University Bluffs Filing 4A

CPC PUZ 19-0004, CPC PUD 19-00005
& AR NV 19-00184

May 28, 2019

Mike Schultz, AICP
Principal Planner

COMPOSITE ANALYSIS

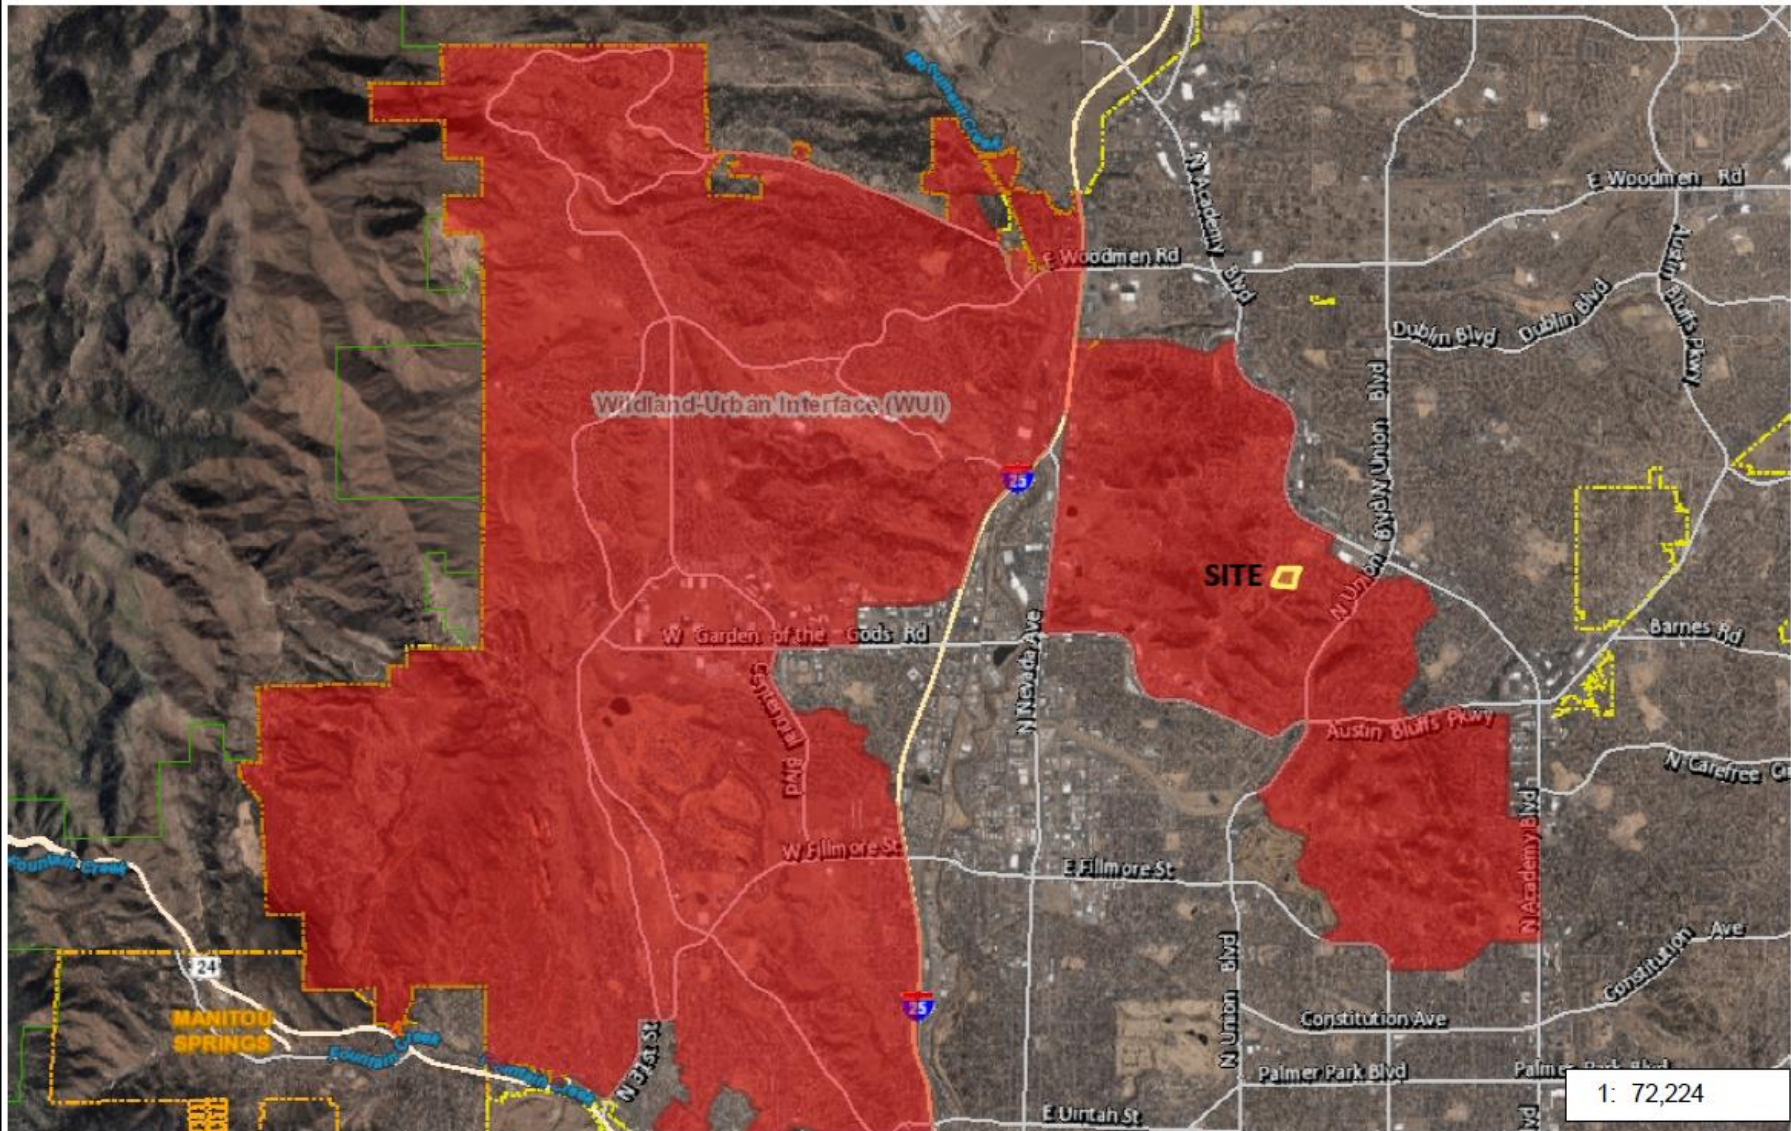
Areas in purple represent slopes greater than 25%

Current development requirements and Fire Wise have impacts on infill sites

FIGURE 11

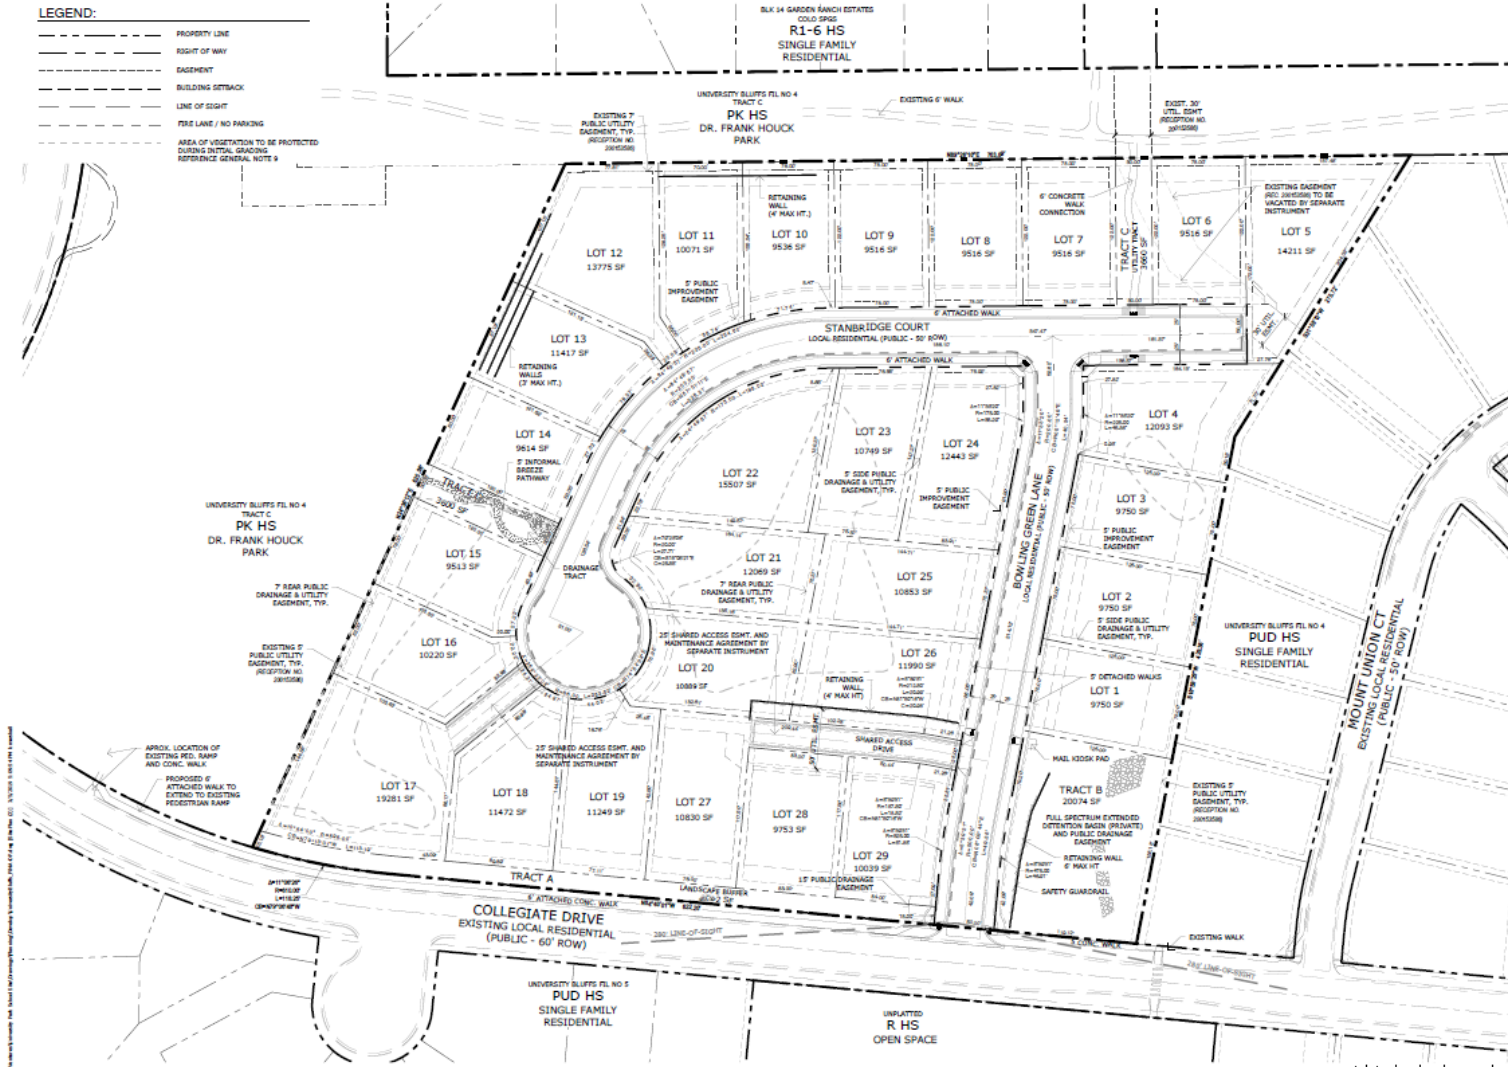
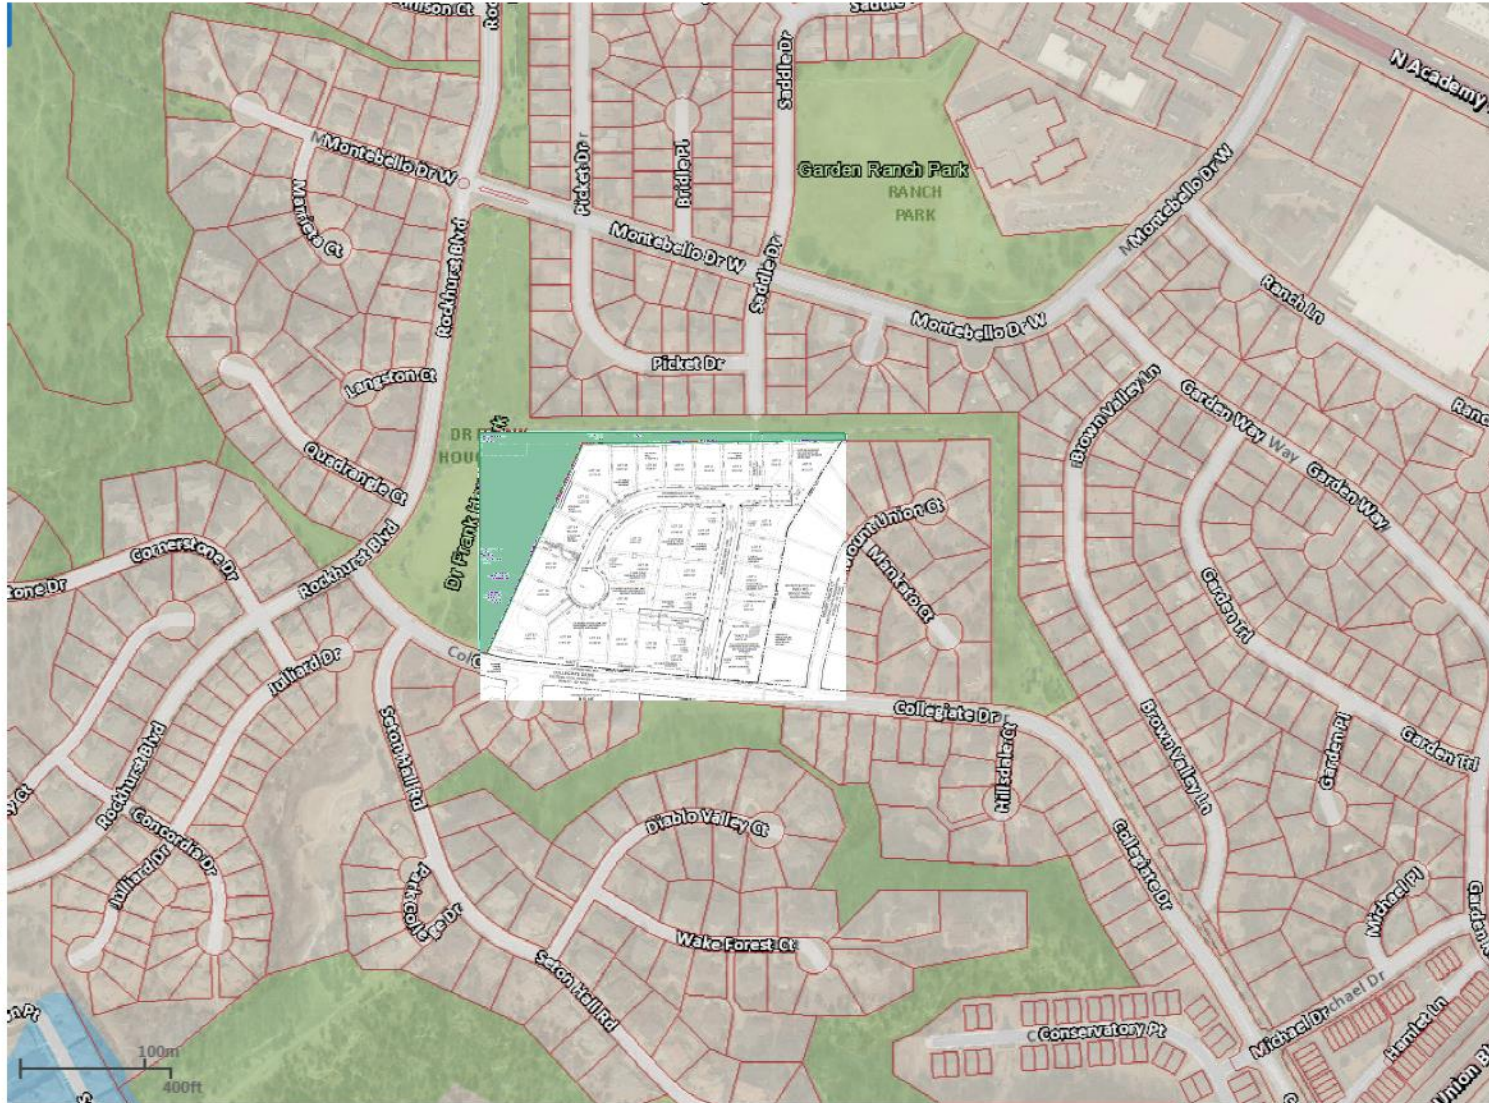
1. Move fire lane to the east side of Bowling Green Lane in order to allow proper turning radius to access the shared driveway on the west side.
